SECTION 009111 - ADDENDUM NUMBER 2

- 1.1 **DATE: FEBRUARY 2, 2026,**
- 1.2 **PROJECT: SHERIDAN PUBLIC LIBRARY BUILDING ADDITION, RENOVATIONS & SITE IMPROVEMENTS:**
- 1.3 **PROJECT NUMBER: 25050**
- 1.4 **OWNER: SHERIDAN PUBLIC LIBRARY, 103 W 1ST STREET, SHERIDAN, IN 46069**
- 1.5 **ARCHITECT: ODLE MCGUIRE SHOOK MATTHEW R. MAYOL #IN19900090**

DA101
FIRST FLOOR DEMO PLAN & MEZZANINE DEMO PLAN

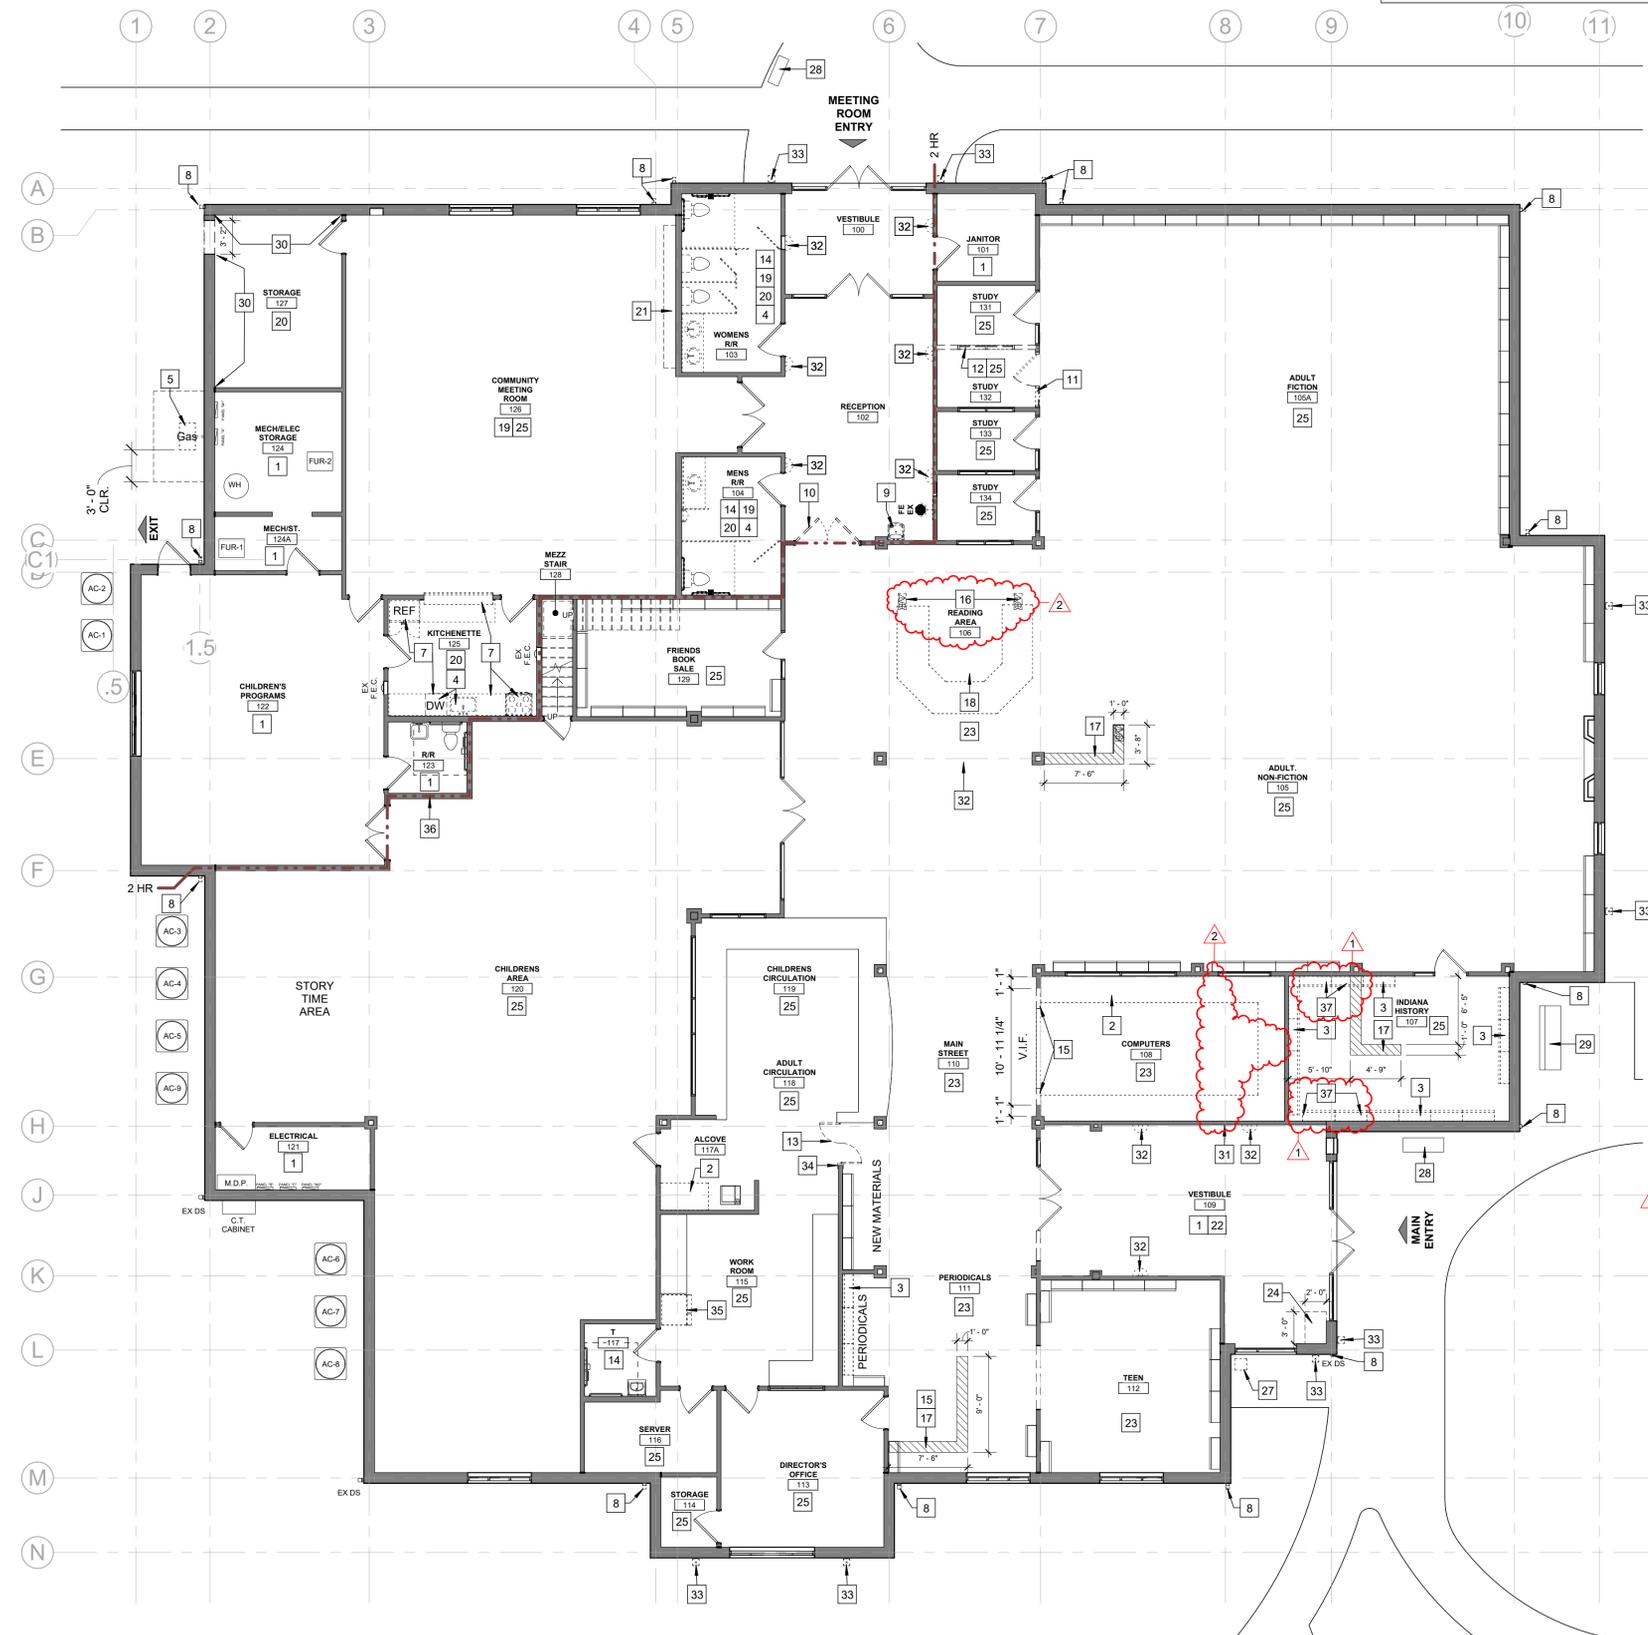
5.3 DA101 FIRST FLOOR DEMO PLAN

- A. Demo Plan Notes
 - 1. Change note 15 to read: "Remove Ex. Wood floor and base this area. Prep for new work"
 - 2. Change note 16 to read: "Not used"
 - 3. Computers 108 – Remove Note 16.

4. Reading Area 106 – Remove Plan Note 16

12. REMOVE BORROWED LIGHT COMPLETE.
13. REMOVE FLIPPER DOORS COMPLETE.
14. REMOVE WALL COVERING AND EXISTING 5/8" DRYWALL COMPLETE.
15. REMOVE EX. WOOD FLOOR AND WOOD BASE THIS AREA. PREP FOR NEW WORK

16. NOT USED.
17. TRENCH CONCRETE FLOOR FOR NEW POWER/DATA THIS LOCATION. REF. 'E' SERIES DWGS.
18. REMOVE WOOD CIRC. DESK COMPLETE.
19. REMOVE CEILING COMPLETE.

A101
FIRST FLOOR PLAN &
MEZZANINE FLOOR PLAN

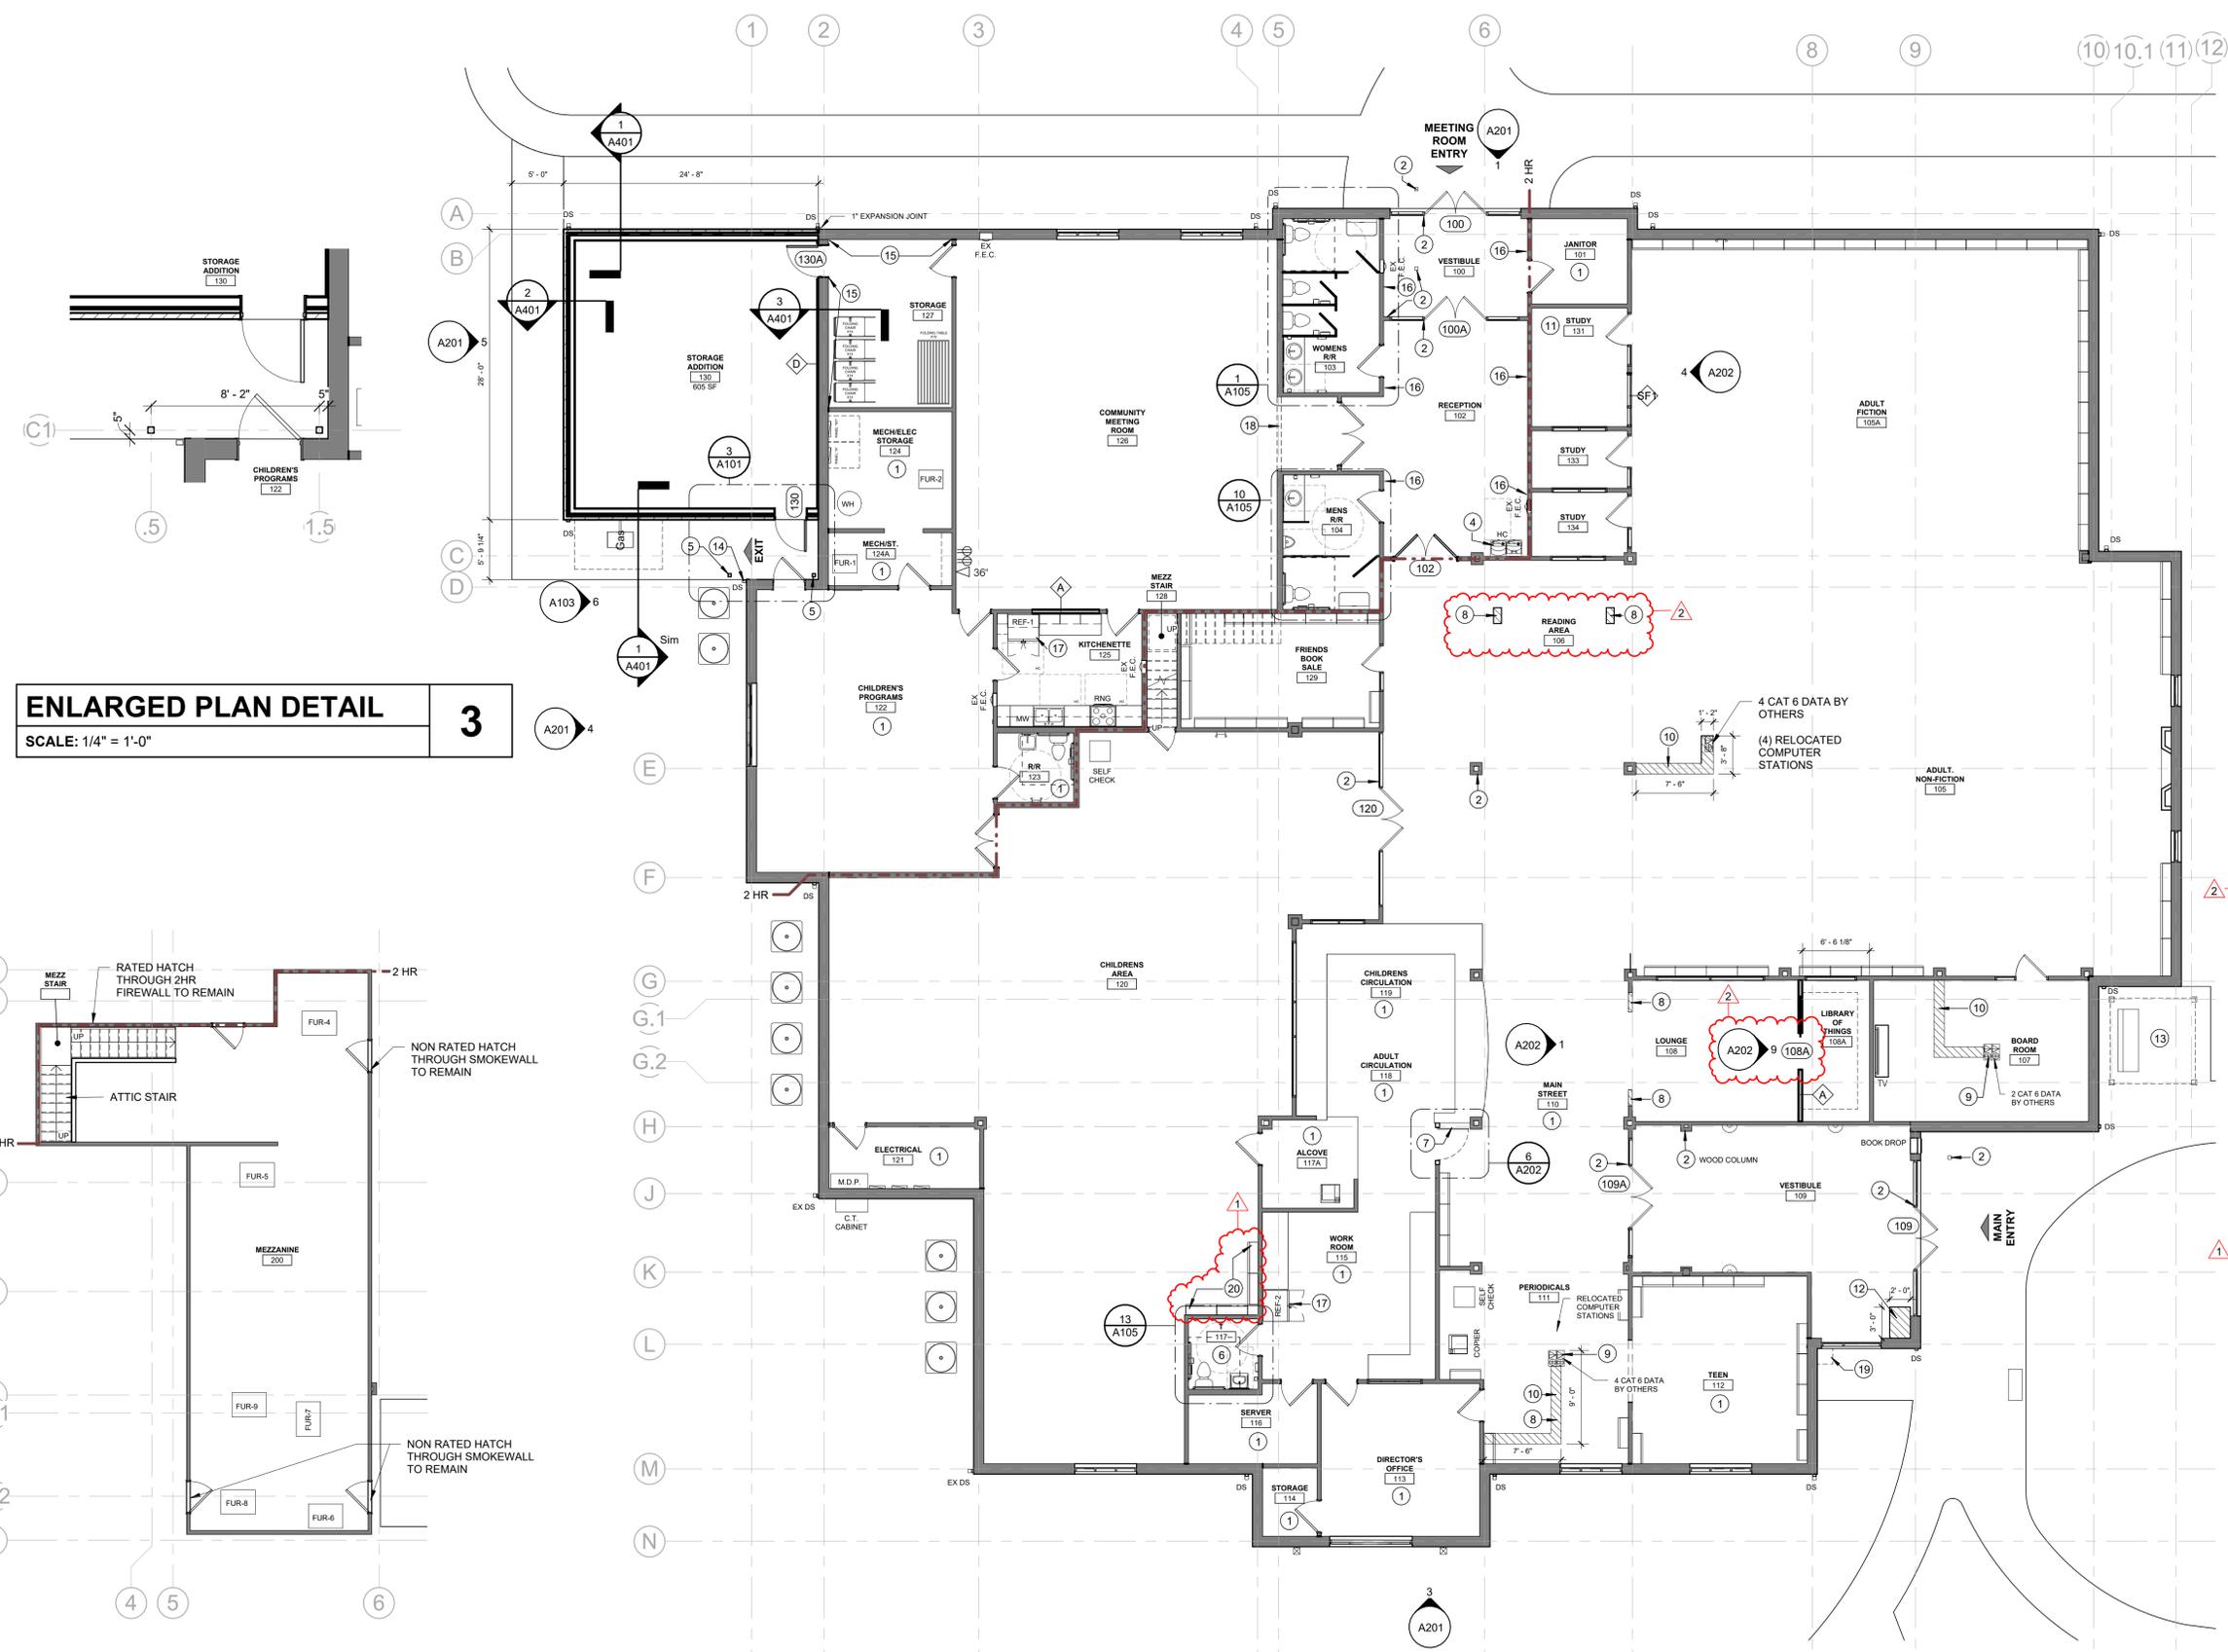
5.4 A101 FIRST FLOOR PLAN

A. Plan Notes

1. Change Plan Note 8 to read: "Patch and repair wood floor this area location. Use wood flooring from owner provided attic stock located in Mezzanine 200". Note: thew
 - a. The wood floor was determined to be glue down type so it is best to leave it in the Library of Things Room 108A and patch slab cut areas with attic stock. If for some reason it is determined that the attic stock is not acceptable Allowance monies will be allocated for floor patch and repair.
2. Reading Area 106 – Remove Plan Note 8

B. Lounge 105 – add Interior Elevation 9/A202

- PATCH AND REPAIR WOOD FLOOR THIS LOCATION. USE WOOD FLOORING FROM OWNER PROVIDED SURPLUS LOCATED IN MEZZANINE 200.
- NEW FLOOR POWER & DATA. REF. "E" SERIES DWGS.

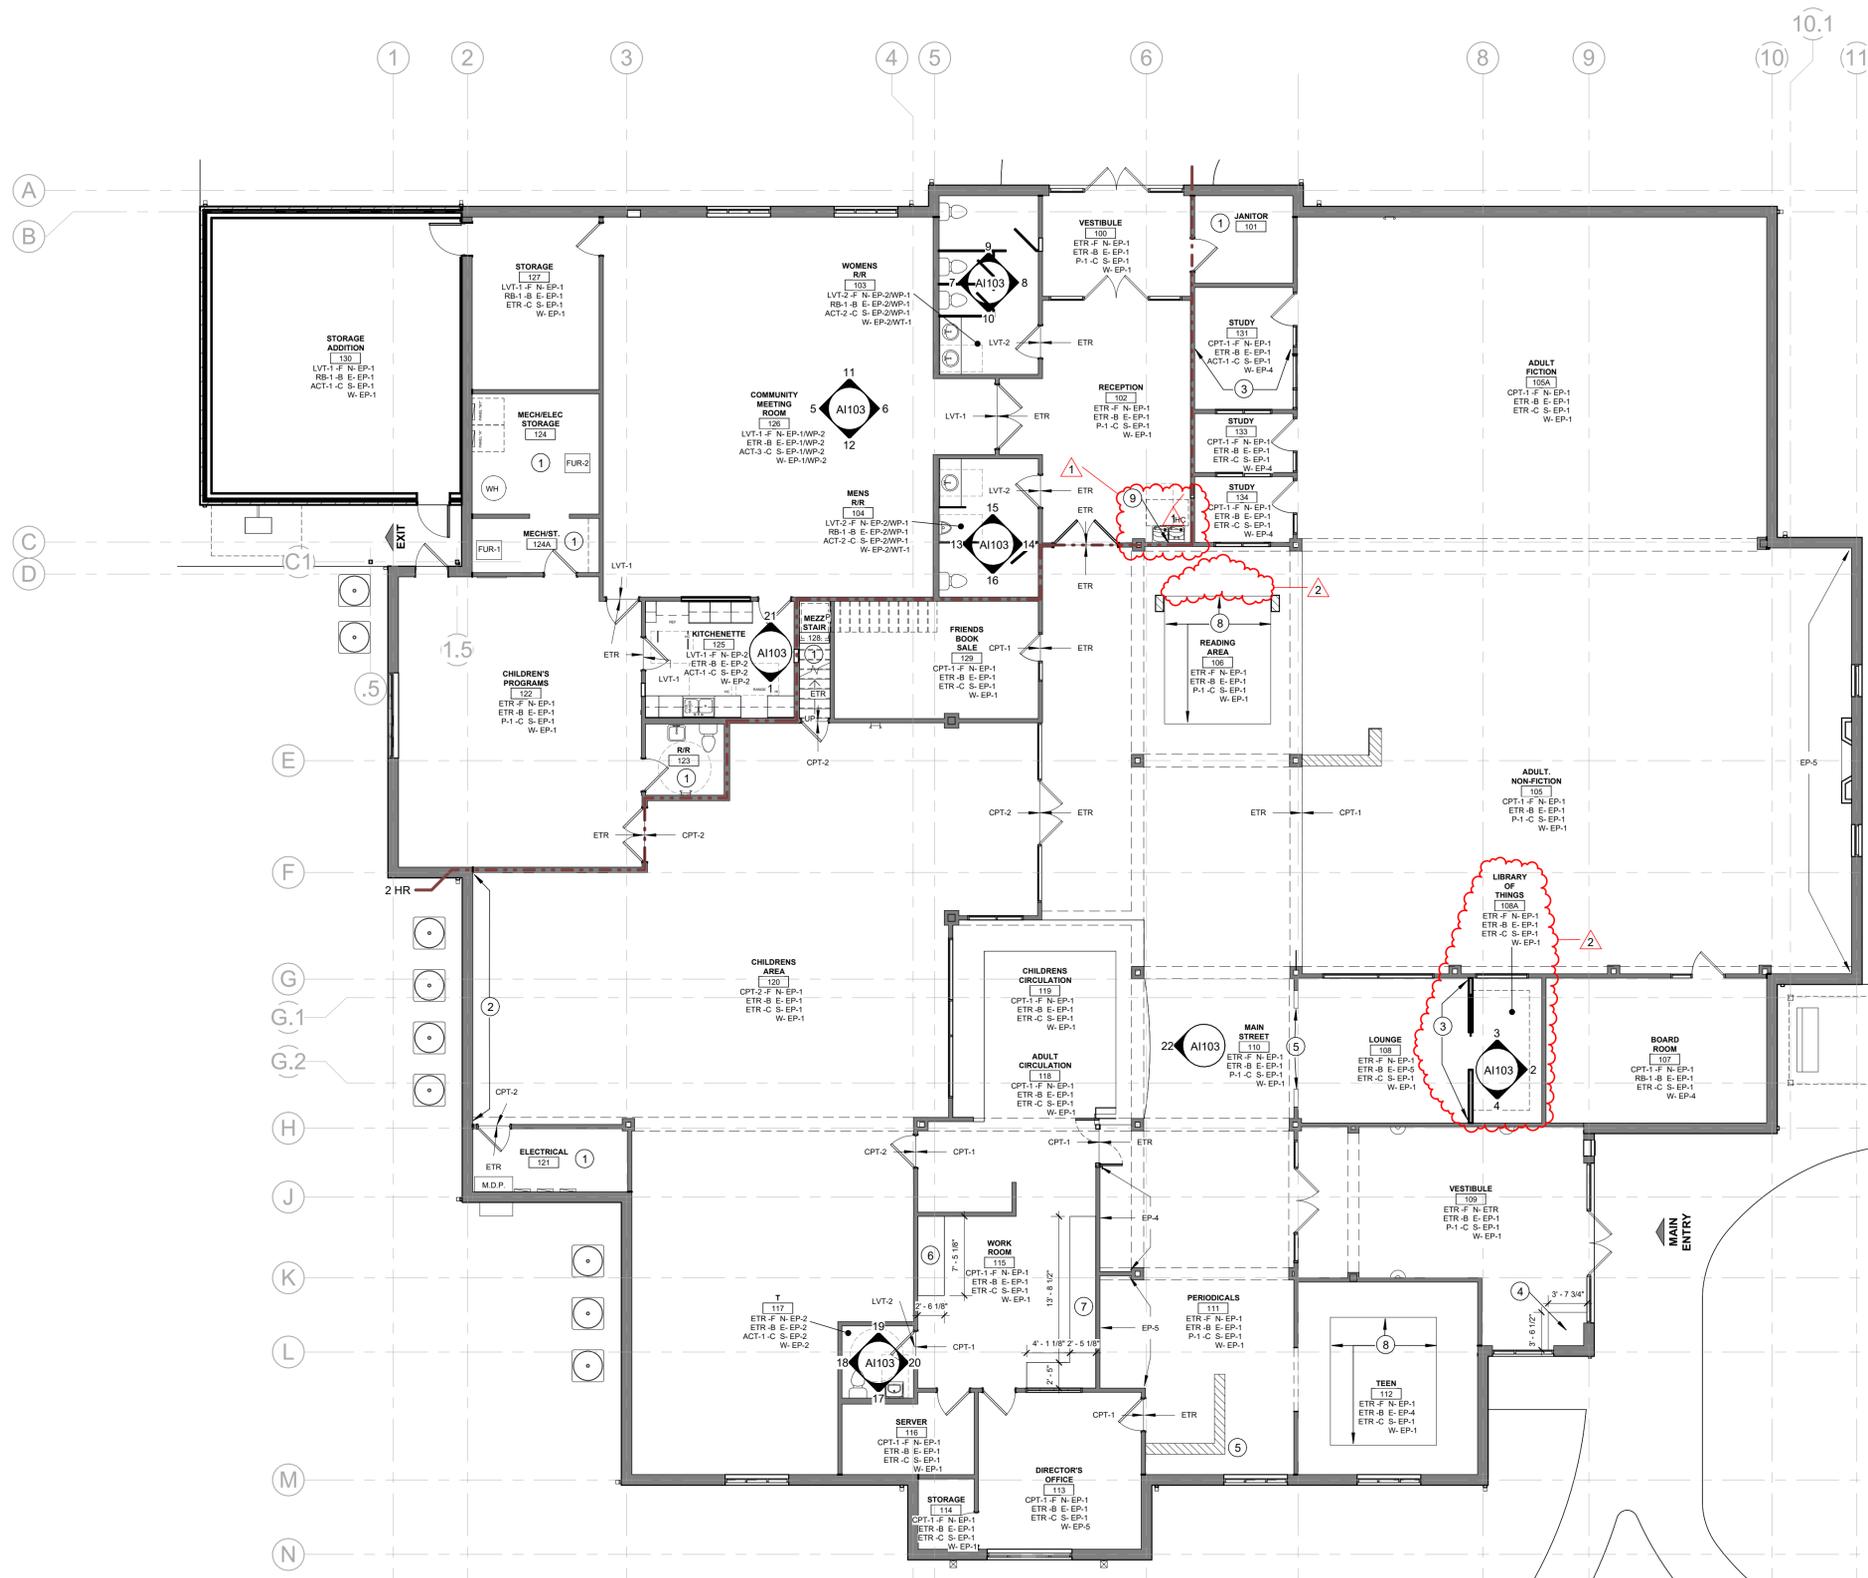
5.5 A202 INTERIOR ELEVATION, ENLARGED PLAN, APPLIANCE SCHEDULE & DETAILS

A. Add Elevation 9 – Pocket Door Elevation
